Spicer Road Realty Subdivision Thompson, Connecticut

Eastern Connecticut Environmental Review Team Report

Environmental Review Report

For the
Inland Wetlands Commission
Thompson, Connecticut

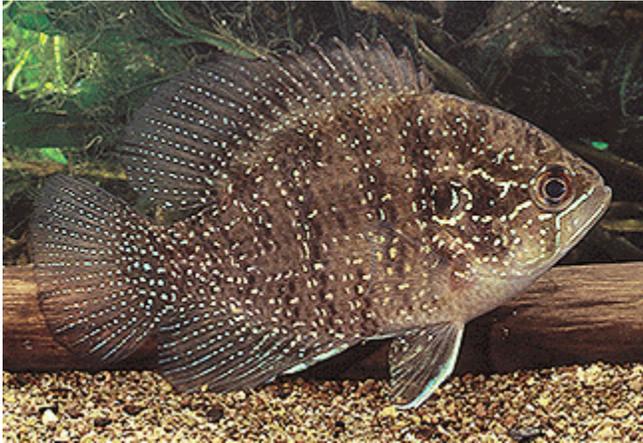
1. The Department would like to encourage the developer and the Town of Thompson to consider alternatives to the traditional curbing and gutter systems, such as grass drainage channels, water quality swales and pervious pavement, to improve pollutant removal and reduce the volume of stormwater runoff directed to one discharge location.
2. No erosion and sediment control details were provided with the ERT materials to show how Robbins Brook will be protected during bridge construction. Some type of coffer dam, perhaps using sand bags, that will divert stream flow around the work site

and retain sediment from the disturbance of the stream bank should be considered. A plan for water-handling, during construction and during emergency circumstances, must also be prepared.

3. Although the riprap stilling basin and swale at FES 101 will provide velocity dissipation and some sediment retention, an alternative design such as the combination of the stilling basin and a grassed water quality swale or bioretention area should be considered to improve pollutant removal prior to the discharge to the Five-Mile River, and to reduce the impact to the wetlands in the area

4. No details were provided to show how the 2:1 (horiz:vert) slopes on the eastern side of the proposed roadway will be stabilized. Although riprap swales are shown above these slopes, the Connecticut Guidelines for Soil Erosion and Sediment Control require reverse slope benches or other engineered slope stabilization measures whenever the vertical height of any slope steeper than 3:1 exceeds 15 feet. In addition, the Department recommends the use of erosion control matting for 3:1 slopes and steeper. The site development plan must address this issue.
